## TECHNICAL SERVICE BULLETIN

**Product:** Cornelius 60Hz/50Hz Viper

**Subject:** Updated Power Connection Viper Switch PCBA Analog Pressure Cut-off

**File:** TSB-25-BVP-1

### 4. Field Service Instructions - Harness Switch Procedure

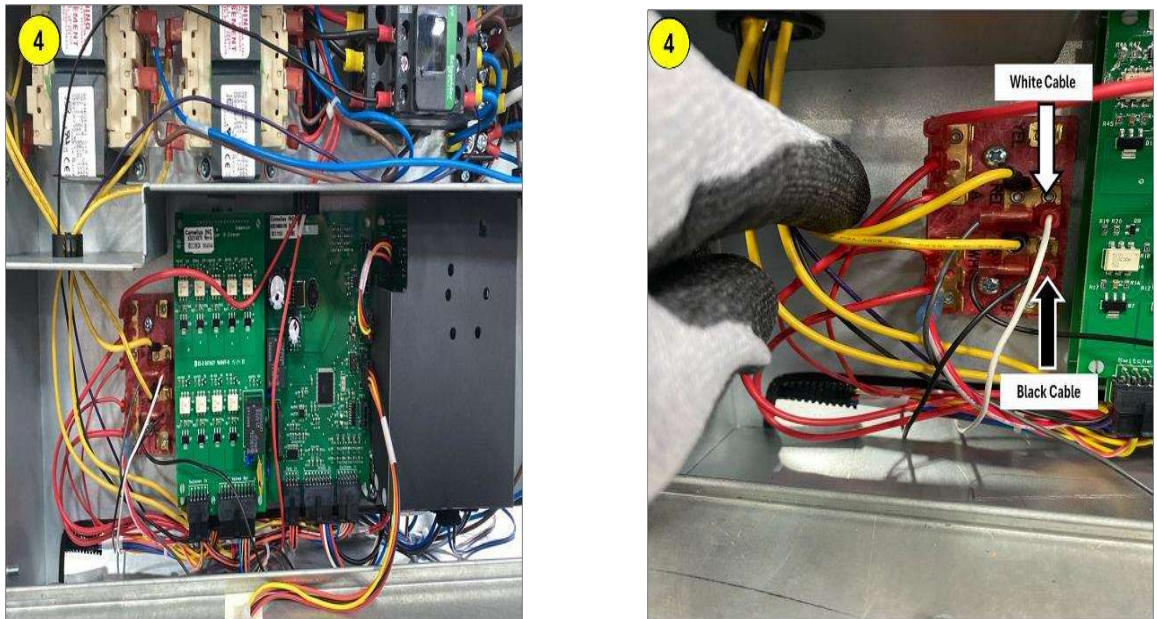
Change the transformer power connection to the Switch Transducer PCBA from 24.5 Volts (Yellow Side) to 26.4 Volts (Red Side).

1. Locate the terminals that supply power to the white and black wires on the Switch PCBA
2. Move the power terminals from the yellow winding of the transformer to the red winding, as indicated in the wiring diagram below.

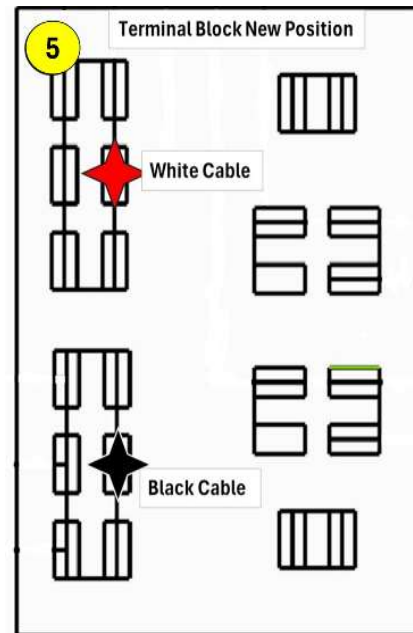
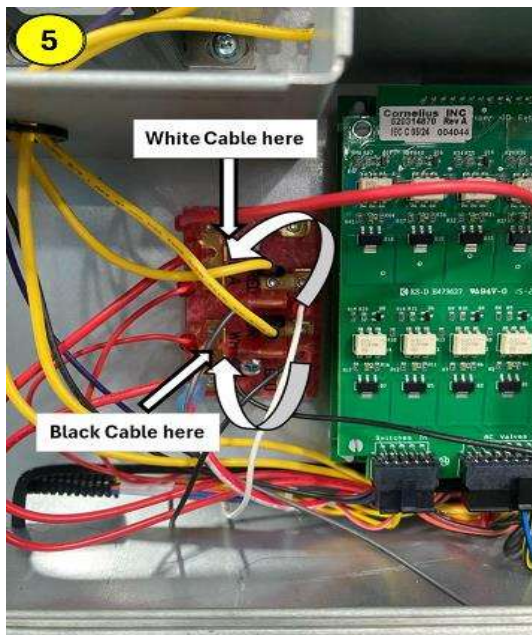
4. Locate the terminal block located on the lower left side of the electrical box, locate the harness with black and white wires, now to disconnect them hold the electrical terminal and pull in the opposite direction to the connection, you can use some needle-nose pliers.

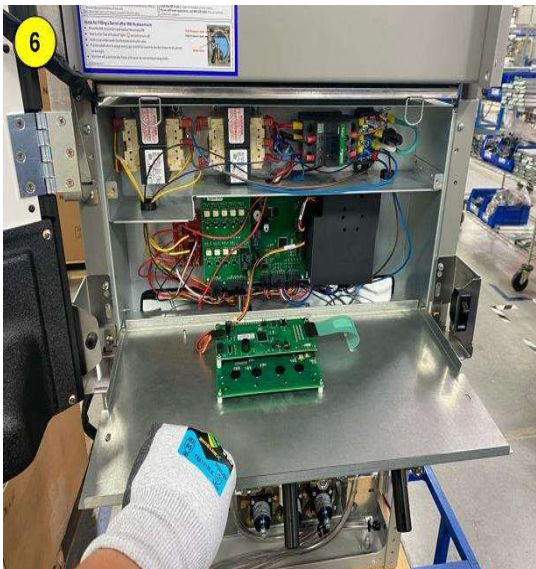
5. Change the black and white wires that are being fed by the horizontal yellow terminals of the transformer and put them on the red ones that are in a vertical position.
